PLANNING & HERITAGE STATEMENT

Site: 1-15 Queen Victoria Street / 145-148 Friar
Street, Reading RG1 1SY
Application by: The Thackery Estates
Lead Consultant: Mr Paul S Bottomley
Date: 8th September 2025.
Our Ref: URB-482b-ST13a.

1.1 This planning statement is prepared by Mr Paul S Bottomley BA (Hons), MA, MRTPI of Town Planning Bureau and is presented in support of a planning application under Section 96a of the Town and Country Planning Act 1990 (“96a”) for a non-material amendment to planning permission ref: 240422 and Section 19 Planning (Listed Building & Conservation Act) 1990 (“S19”) for an amendment to listed building consent ref: 240404 (“the application”).

1-15 QVS Shopfront Transom

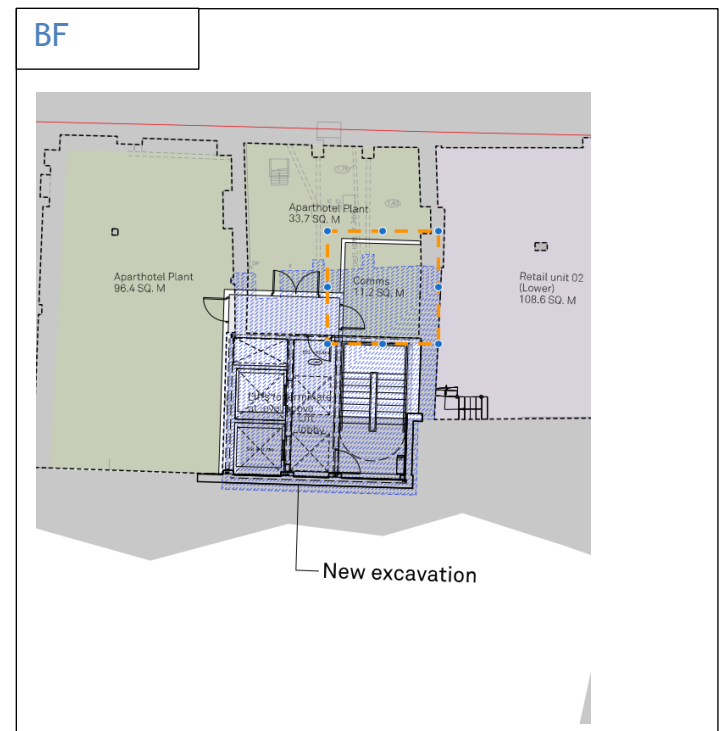
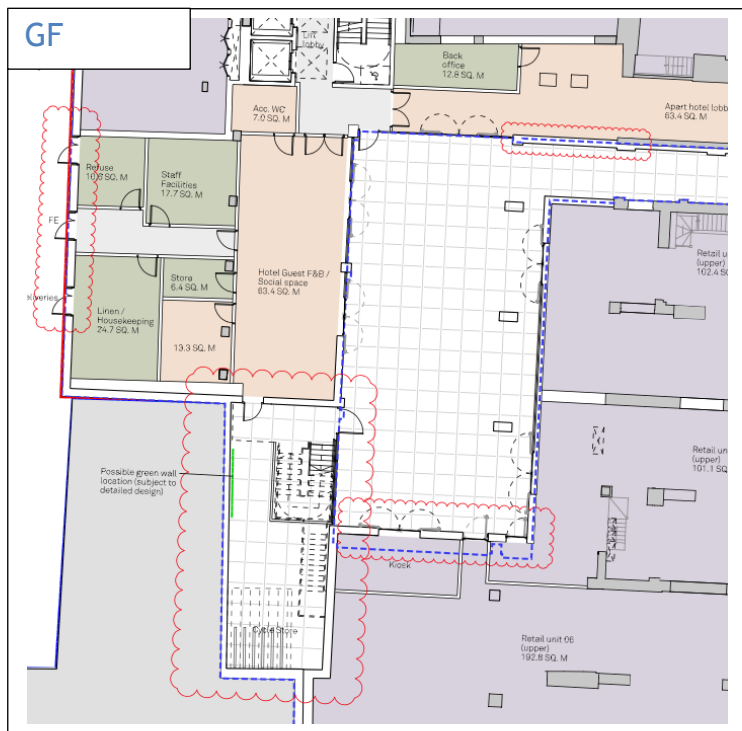
1.30 **Transom:** the front elevations of the shop fronts have been designed with single pane glazing. However, during detailed design the weight of a single pane of secure glazing, the manufacture of the shop front has advised a vertical transom is required. This would be modest and add detail and interest to the shop front. The change is non-material.
